Felps Work Order #: 6877, dated 06/10/25,  
has been reviewed by AGCM.

TEMPORARY POWER FOR  
TEMPORARY PORTABLES  
AT JUNIOR HIGH`

STK503655	WR #:	6877
me: La Vernia Isd	Wo Type:	New Construction
Sep: 15188000	Svc. Addr.:	195 Bluebonnet Rd
City 19 - LaVernia City	Tax Exempt?	Yes
County:	Wilson County	
WCESD? Dist. 1 & 3	Rate:	200: Small Commercial
Staked By:	Benny	
Work Plan #:	System Improvement/New Constr	
Date:	06/10/2025	
Const Code:	Contract	
Primary Phone	8307796600	
Billing Addr. (If different from Svc. Address)	Other Phone 1	
	Other Phone 2

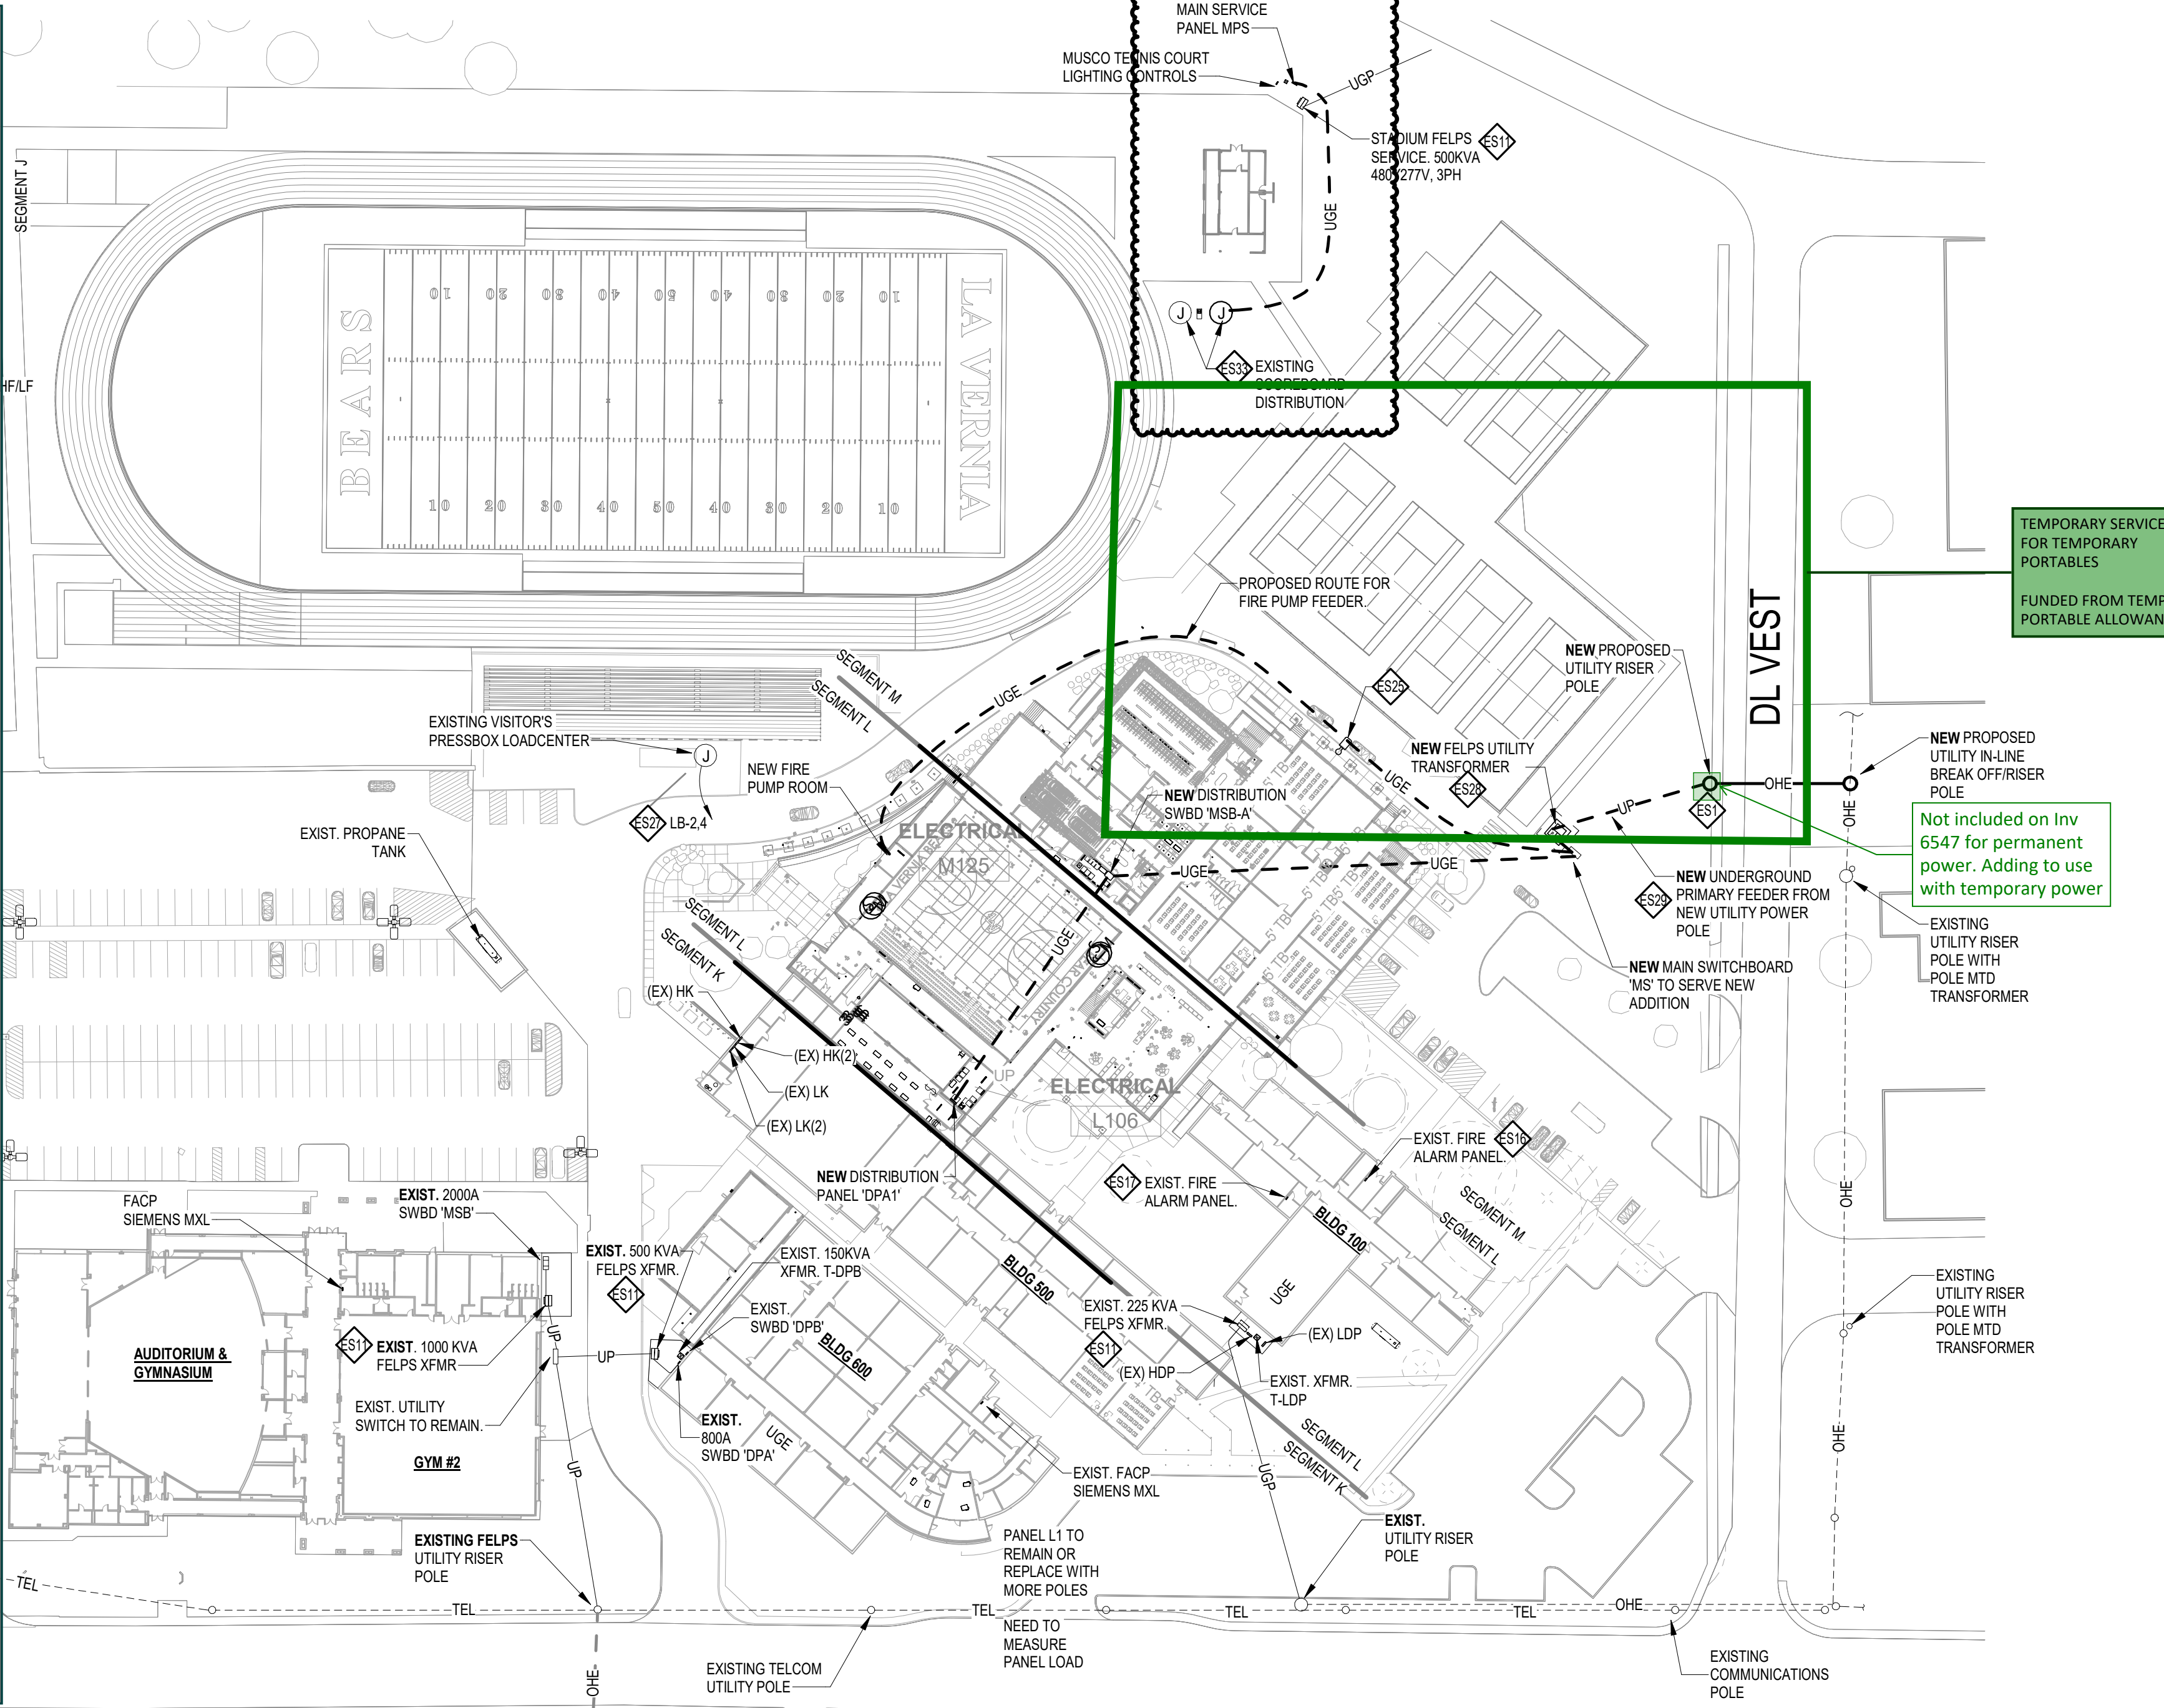
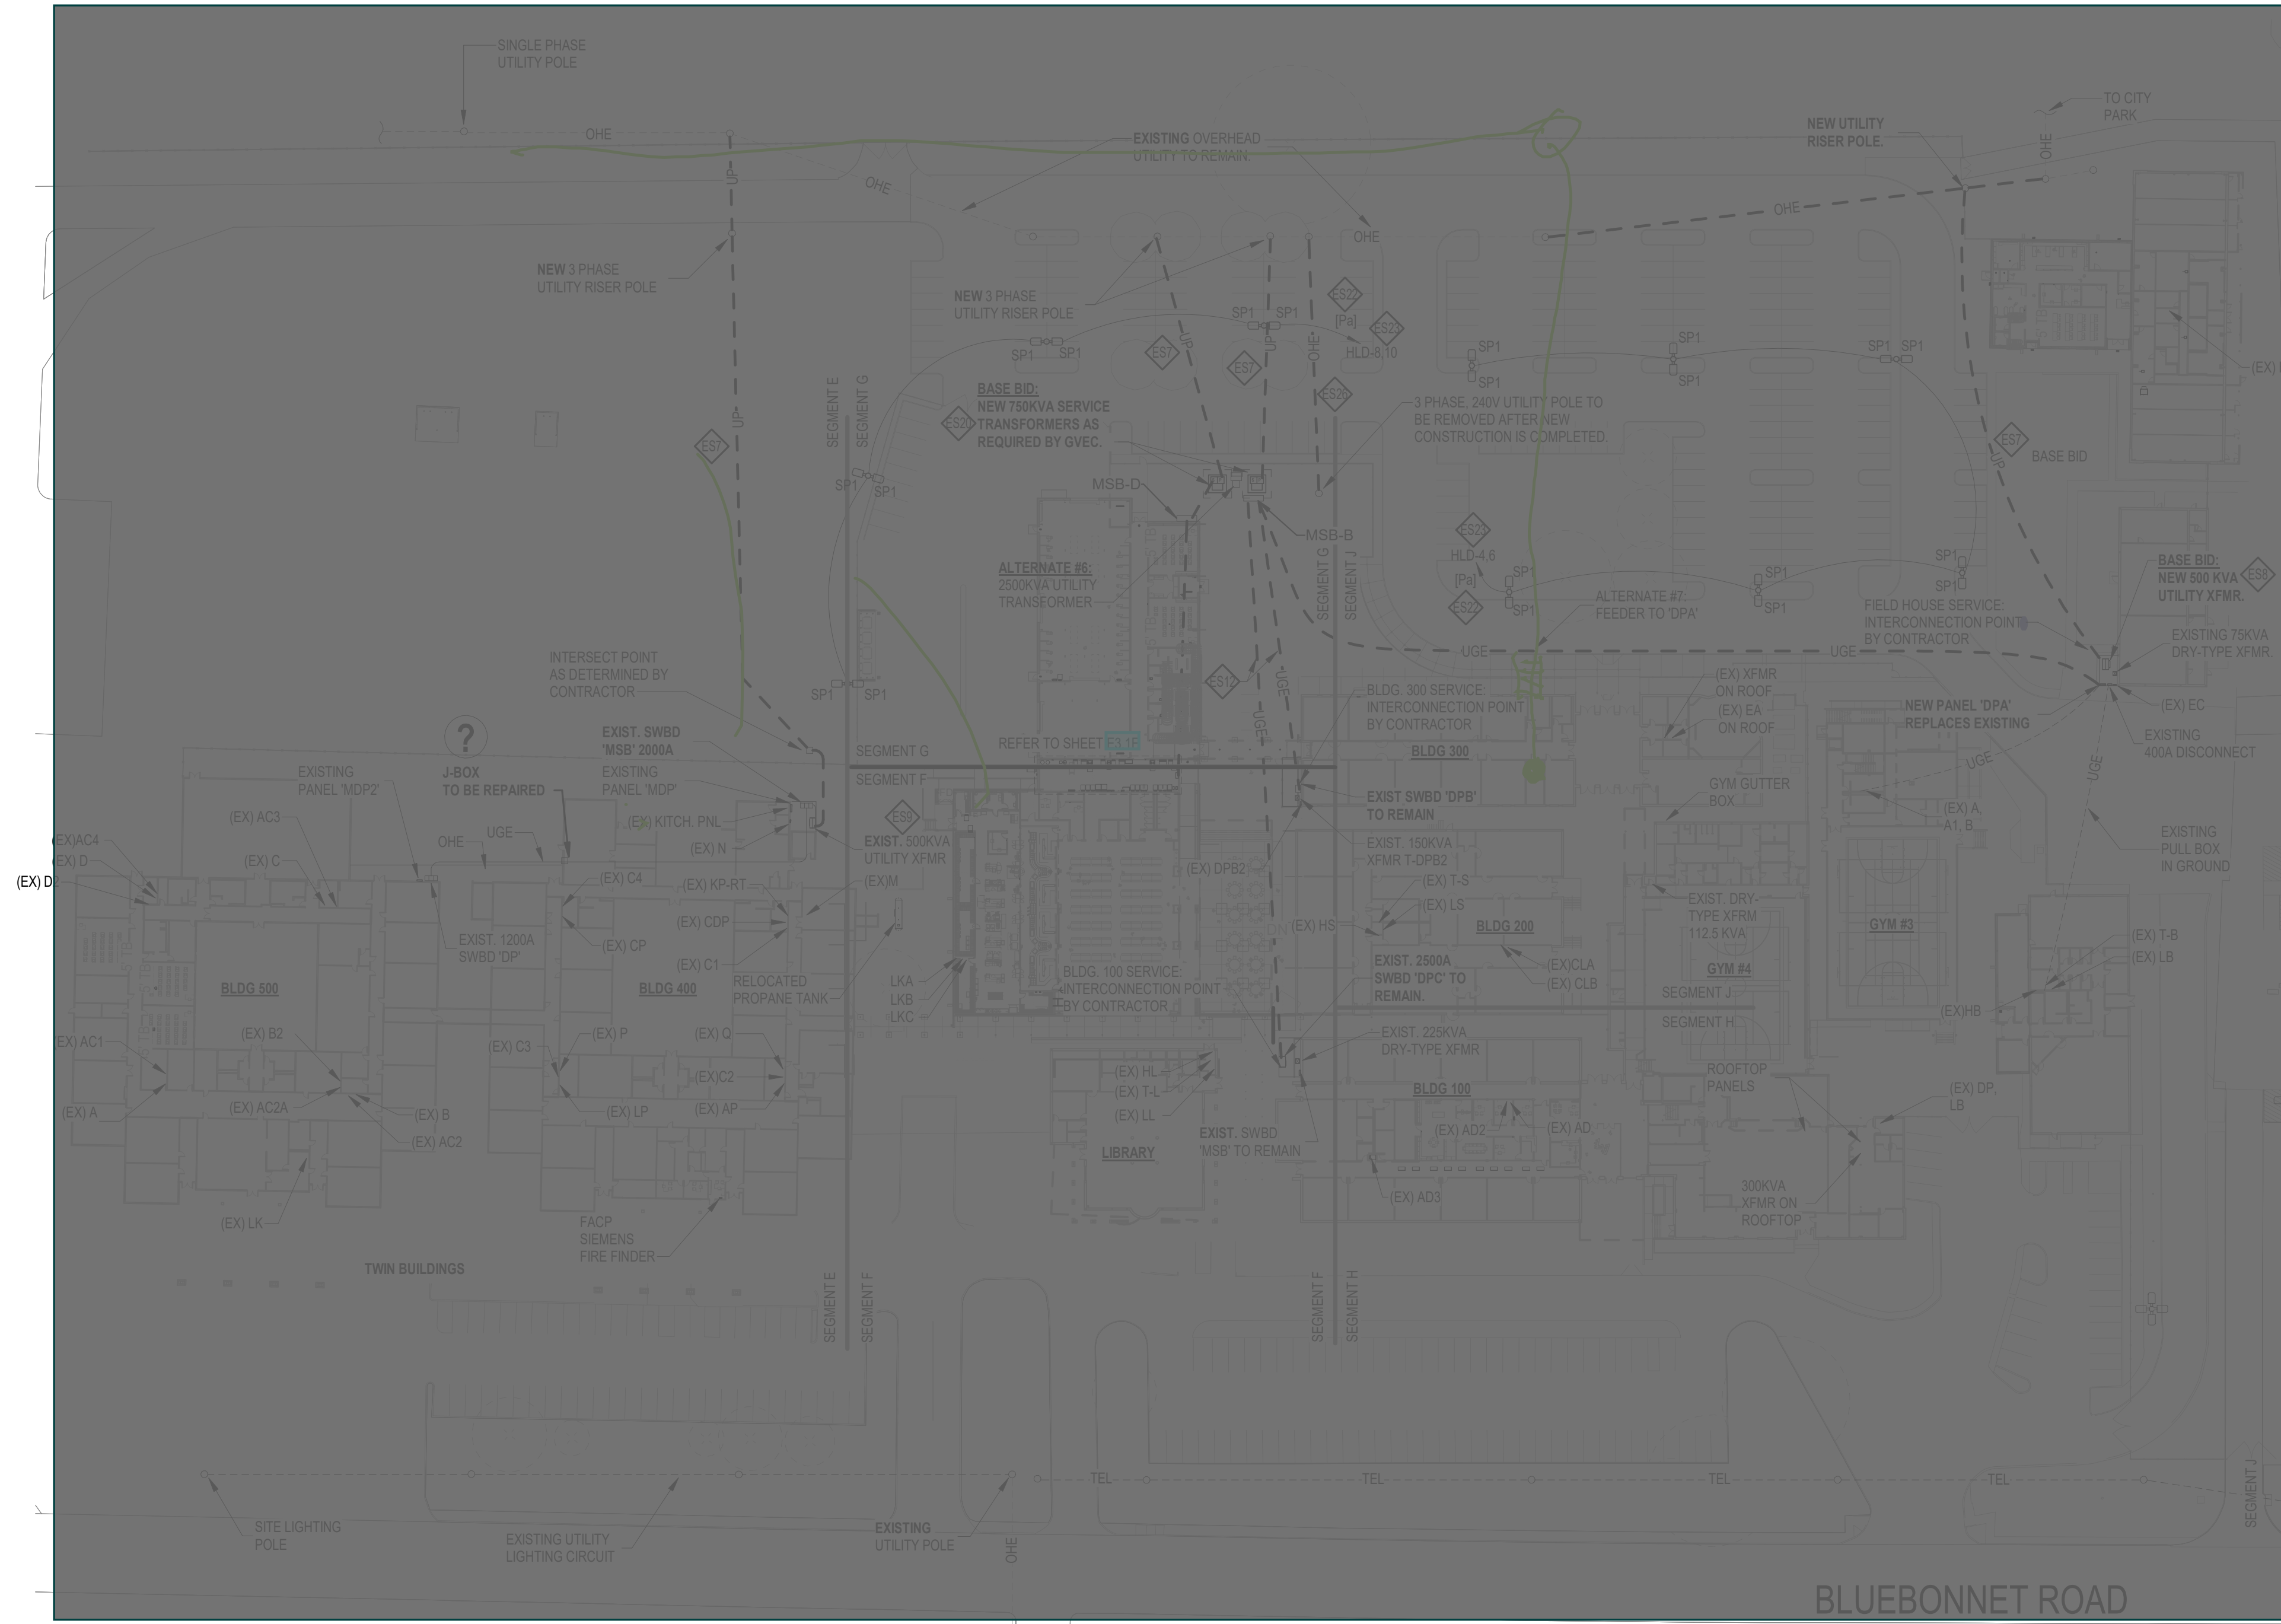
No Exceptions as submitted.
